DEVELOPMENT DETERMINATION PANEL MEETING

WEDNESDAY 27 MARCH 2024

Agenda for a Meeting of the Development Determination Panel to be held on Wednesday 27 March 2024 via teleconference Commencing at 10:00 AM

DEVELOPMENT ASSESSMENT REPORT

Figure 1 - Red shading indicating extent of height variation - limited to eaves of primary dwelling.

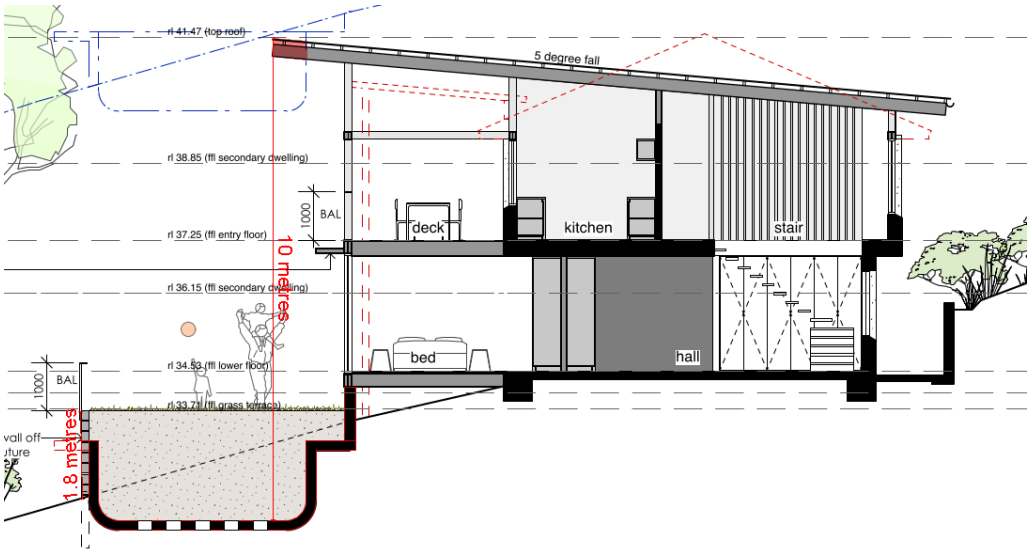
Comment
The height of buildings within the area are considered to be varied as a result of the sloping topography and scattered nature of allotments. When compared to the existing building's roof ridge of the primary dwelling (which is RL41.54 - RL41.44), the proposal is considered to be consistent (Max: RL41.47 - area of non-compliance). Majority of the building is compliant with the 8.5m building standard, with the extent of non-compliance limited to an eave that happens to extend over an existing swimming pool (which is proposed to be filled). Once the pool is filled, the overall building height to this area of building will be approximately 7.76m. The dwelling will present as single storey to the street. The overall scale of the proposal is consistent with built form across the vicinity and is generally compliant with side setbacks and side building envelope controls.

Figure 1. Proposed maximum building height breach (extent of breach indicated by pink shading).

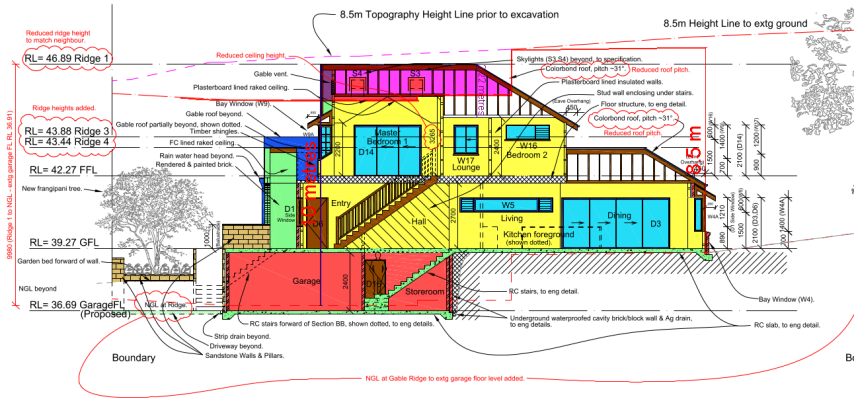
Development standard:	Height of buildings
Requirement:	8.5m
Proposed:	10.0m
Percentage variation to requirement:	17.6%

Amended plans were received which reduced the maximum ridge height from RL47.27 to RL46.89 to align with the maximum ridge line of 36 Francis Street. The amendments reduced the built form, yet did not eliminate the height breach (as a result of the existing ground level). Notwithstanding the numerical noncompliance, the building mass of the proposed dwelling will achieve compatibility and consistency with the building bulk of adjoining properties along Francis Street. 34 Francis Street, which is also up-hill of the subject site, is a three (3) storey dwelling. In this instance, the proposed development will be commensurate with the built form of dwellings along the eastern side of Francis Street. Furthermore, the front setback distance of the first floor level is 8.7 metres, which far exceeds the required minimum 6.0 metres (or prevailing front building line). The first floor level is recessed along all elevations of the building footprint of the ground floor level. Thus creating articulation of the built form, and creating visual relief when viewed from adjoining and nearby properties.

Figure 3. Proposed hourly elevational shadow diagrams to the northern elevation of 36 Francis Street, Fairlight.

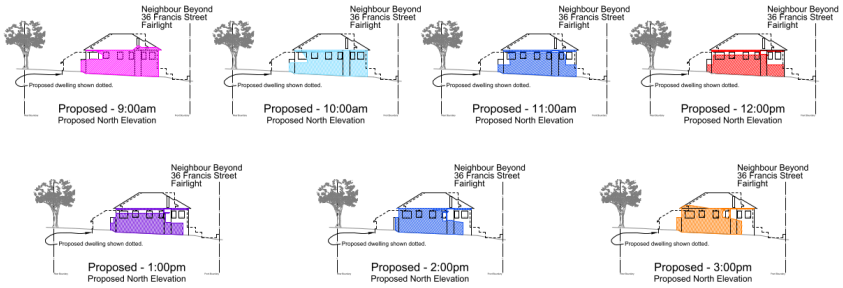
Elevational shadow diagrams with hourly intervals have been provided with this application (see figure below). The subject site has an east to west orientation, therefore requirement (a) applies for this assessment. A floor plan for 36 Francis Street (the property to the south, and indicated in the figure below) is not available on Council's records. Notwithstanding, an assessment of the requirements of (a) above can be undertaken below.

With regards to the solar access to internal living rooms of adjoining properties, the proposed works will increase shadowing to the existing windows along the northern elevation of 36 Francis Street at all hours between 9am-3pm throughout the winter solstice, as indicated in Figure 3. However, there is no confirmation as to whether these windows service an internal living room. The proposed dwelling house proposes a rear setback distance that is generally consistent with the existing rear setback distance while maintaining a single storey element of the proposed dwelling, and is consistent with adjoining properties and this allows for a reasonable level of sunlight to be retained to the northern

Figure 2. Established front boundary line (indicated by red line).

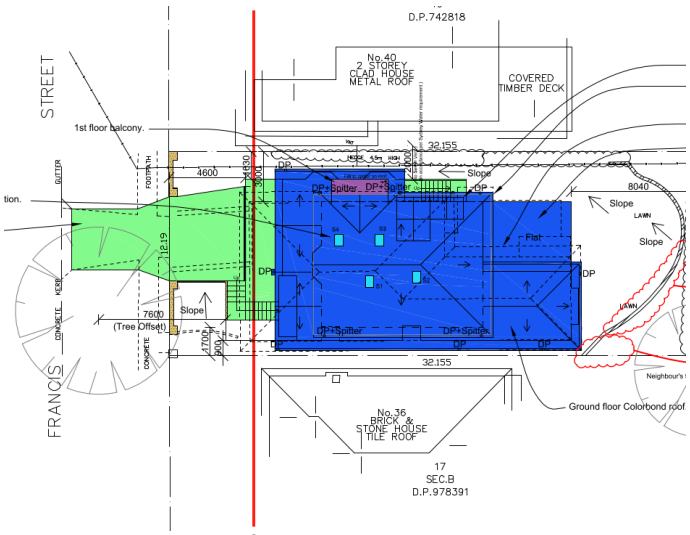
- *Garage level:* 4.5m, consistent with prevailing building line (see figure below).
- *Ground floor level:* 4.6m, consistent with prevailing building line (see figure below).
- *First floor level:* 8.7m.

Figure 1 Section AA prepared by Abigail Larkin Architect Pty Ltd.

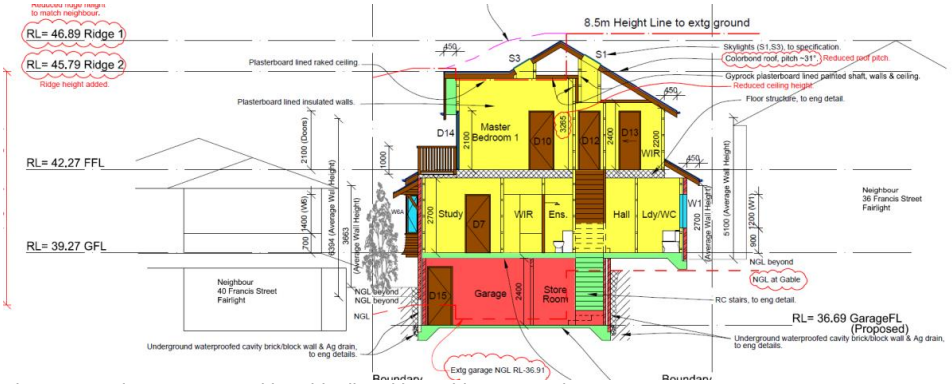
The extent of the variation to the Height of Buildings Development Standard is shown in Section AA and Section BB as extracted below.

Image 1. West Elevation building envelope proposed non-compliances.

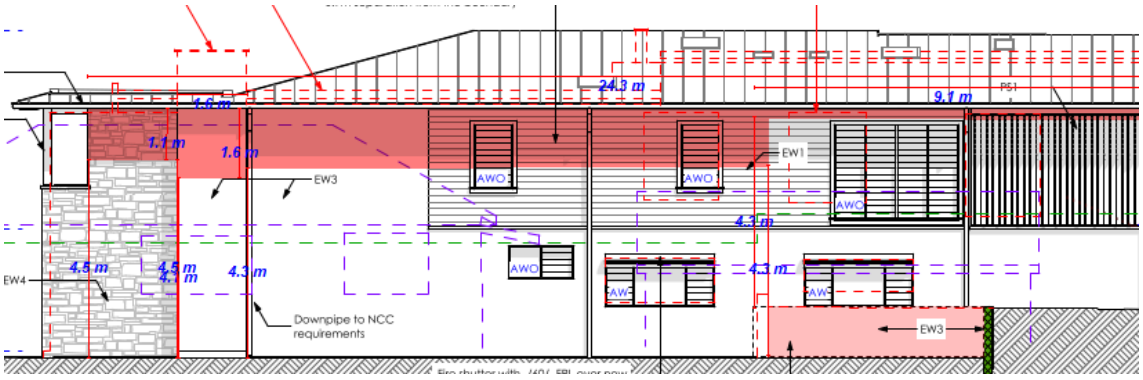
Clause D1.11 *Building Envelope* of P21DCP requires buildings to be sited within an envelope with planes projecting at 45 degrees from a height of 3.5 metres at the side boundaries towards the maximum building height. This proposal has boundary envelope non-compliances on both east and west elevations, as images 1 and 2 below demonstrate.

Image 2. East Elevation building envelope proposed non-compliances.

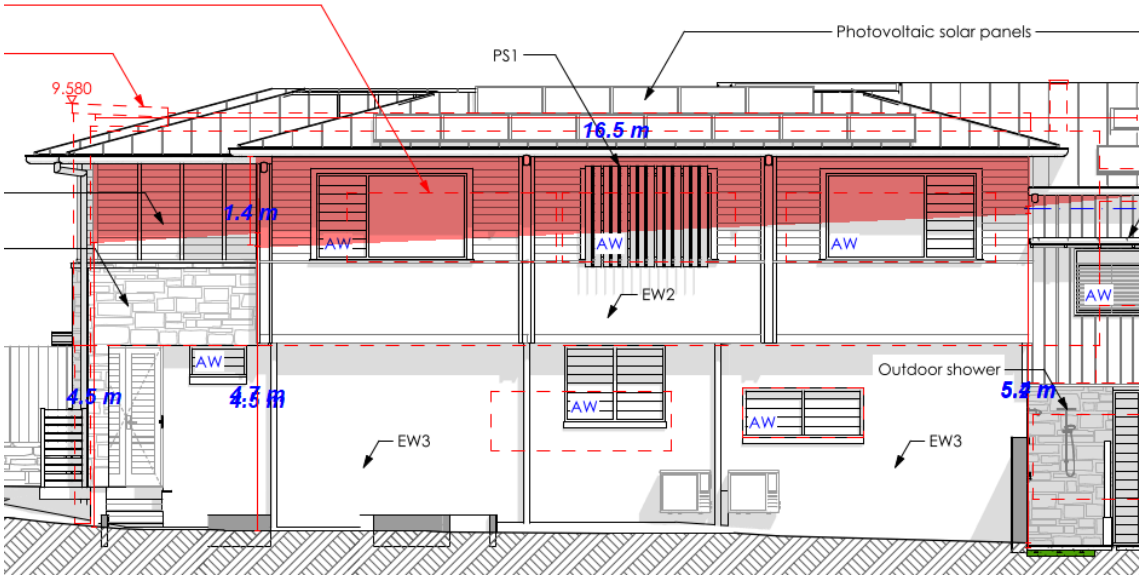
The proposed east elevation building envelope non-compliance is for a length of 16.5m, from a minimum height of nil to a maximum height of 1.4m towards the front of the dwelling.

Figure 1 - Extract of South-West Elevation (as proposed in this application) showing building envelope breach in red.

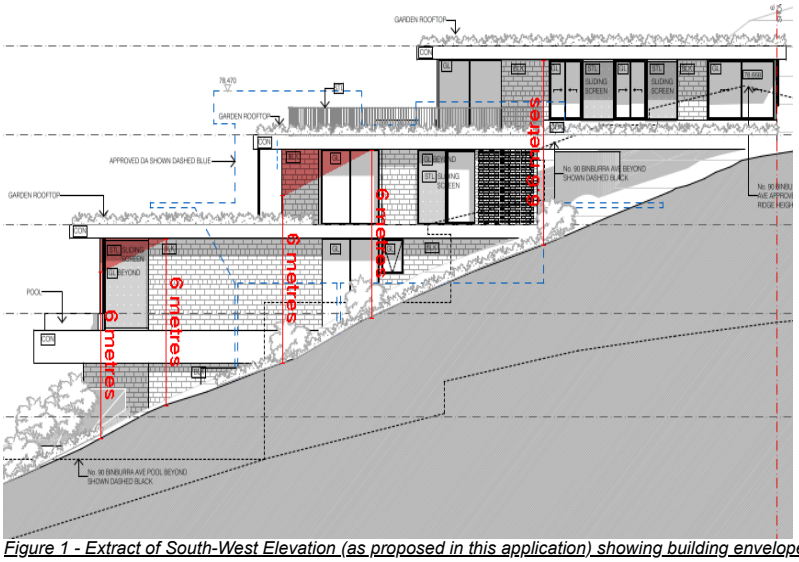
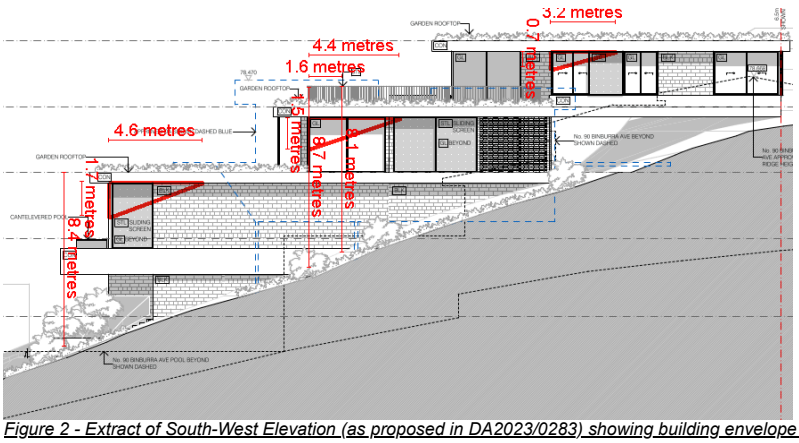
The proposed development encroaches into the side boundary envelope along the south-west elevation as depicted in *Figure 1*, with two sperate corner breaches. The level of non-compliance has been reduced from that originally proposed in DA2023/0283, which contained three, slightly larger, separate breaches, depicted in *Figure 2*.

Figure 3 - Extract of North-East Elevation (as proposed in this application) showing building envelope breach in red.

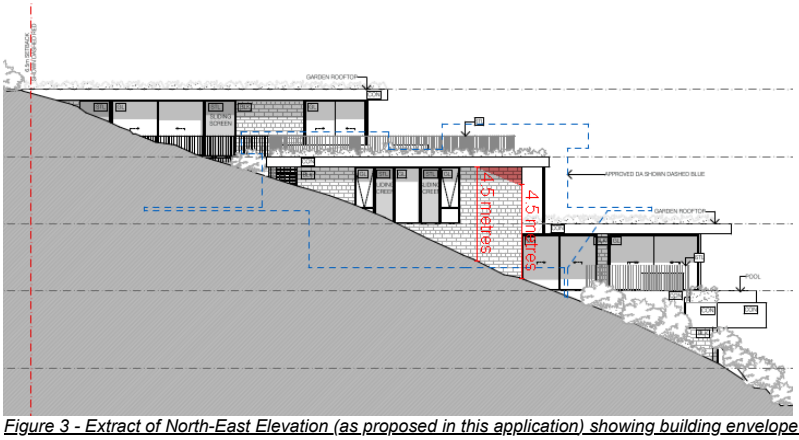
The proposed development encroaches into the side boundary envelope along the north-east elevation as depicted in *Figure 3* below, with one corner breach. This is roughly the same as originally proposed in DA2023/0283.

(Figure 1: Western Elevation - Encroachment shown in red shading)

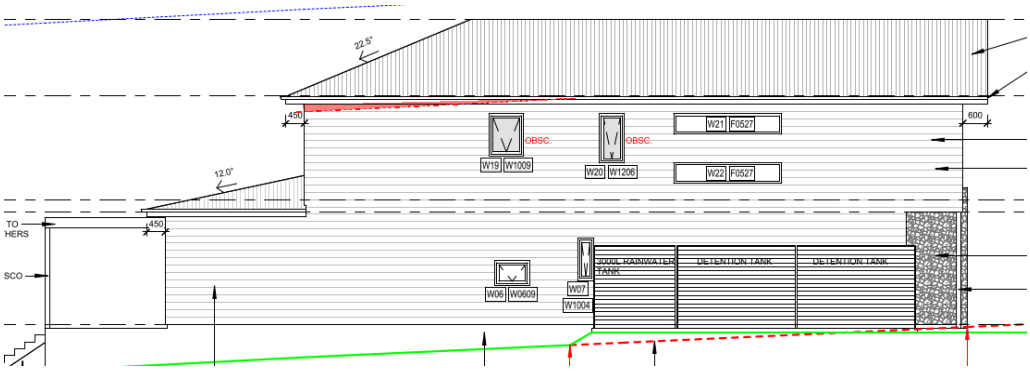
Description of Non-compliance
Clause B3 Side Boundary Envelope requires development to be sited within a 4.0m building envelope to ensure the bulk and scale of the built form is minimised.

The proposed development encroaches the side building envelope on the western elevation, presenting a maximum variation of 12.0% and 4.0% to the eastern elevation (see figures below).

Figure 1 - Plan showing area of additional GFA created by shower/sink adjacent to pool area highlighted in green.

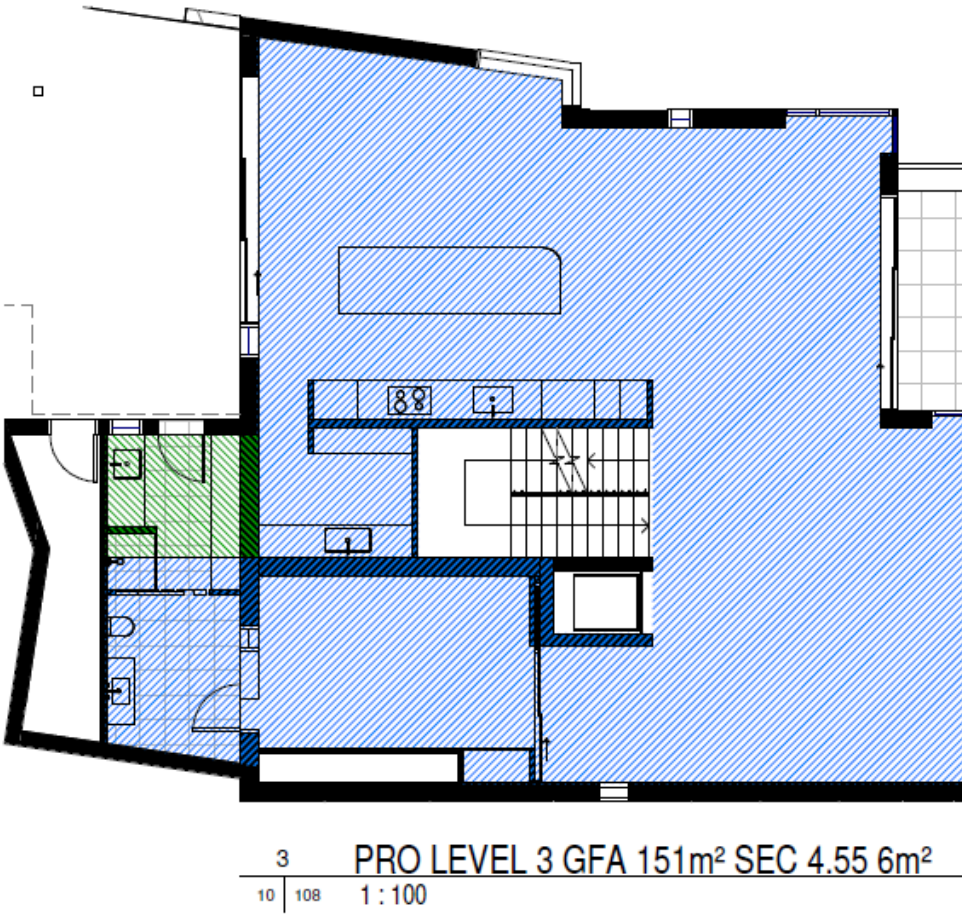
Development standard: Clause 4.4 Gross Floor Area
Requirement: **0.4:1 FSR** (400.5m^2)
Approved: **0.502:1 FSR** (503m^2)
Proposed: **0.508:1 FSR** (509m^2 or 6m^2 increase on approved development)
Percentage of variation: **27%** (Approved at 25.6%)
